UNITED STATES PATENT AND TRADEMARK OFFICE

10/615,077

Office Action Summary	Application No. 10/615,077	Applicant(s) JOHNSON ET AL.	
	Examiner Dang T Nguyen	Art Unit 2824	
	-- The MAILING DATE of this communication appears on the cover sheet with the correspondence address --

DETAILED ACTION

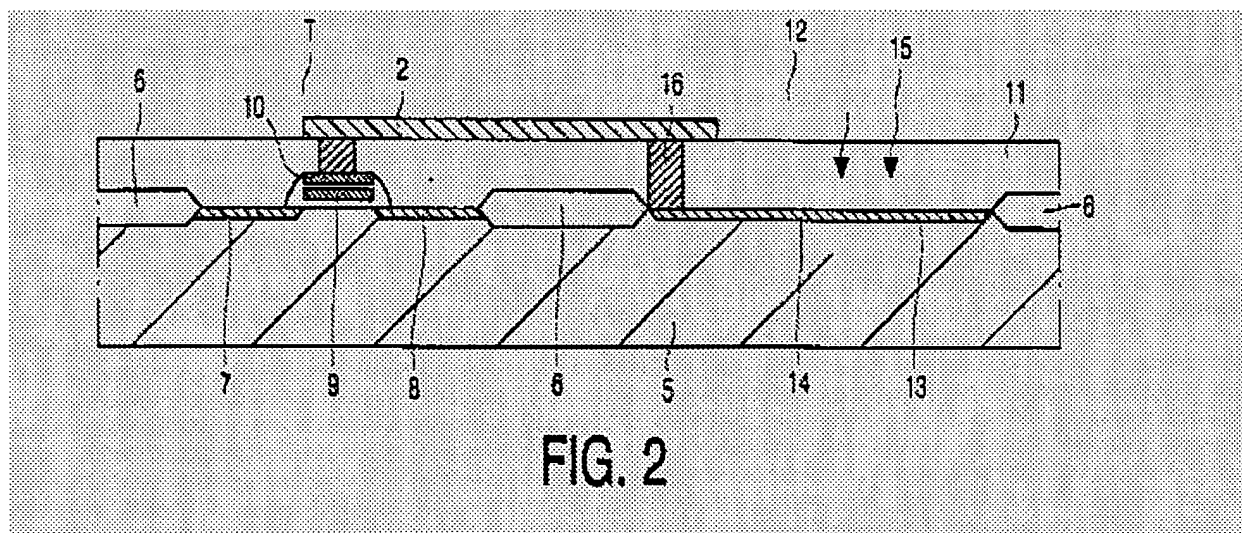
Col. 4 lines 49 – 53, Widdershoven discloses the photodiode 12 is using to prevent under erasure during UV irradiation. Widdershoven clearly teaches the photodiode 12 does not perform any erasure, in addition photodiode 12 is using to preventing erasure. Therefore, photodiode 12 is not an erasing circuitry. As is described Fig. 1 and Fig. 2 of Widdershoven clearly teaches a high-density non-volatile flash memory having no erasing circuitry, see Fig. 2 below

Fig. 2 of Widdershoven discloses the UV radiation [15] is used to erase the flash cell (Col. 1 lines 10-11); therefore, no erasing circuitry in the flash memory.

Fig. 1 of Widdershoven clearly teaches a modified flash cell (11) by UV light having two terminals drain [2] and gate [3]. Therefore, Widdshoven clearly anticipated the two terminals (drain [2] and gate [3]) comprised by the memory cell of claimed invention.

Regarding dependent claim 11, Fig. 2 of Widdershoven discloses wherein the UV light window [15] is located above a control gate [10] of the modified flash cells.

Regarding dependent claim 12, Fig. 2 of Widdershoven discloses wherein the UV light window [15] is located below a substrate of the modified flash cells.

Regarding independent claim 41, Fig. 1 of Widdershoven discloses a system comprising: a non-volatile memory; and an ultraviolet (UV) light window (Fig. 2 [11]) adapted to expose the high-density non-volatile fast memory to UV light (Fig. 2 [15]), wherein the UV light window (Fig. 2 [11]) is located below a substrate (Fig.2 [16]) of the memory.
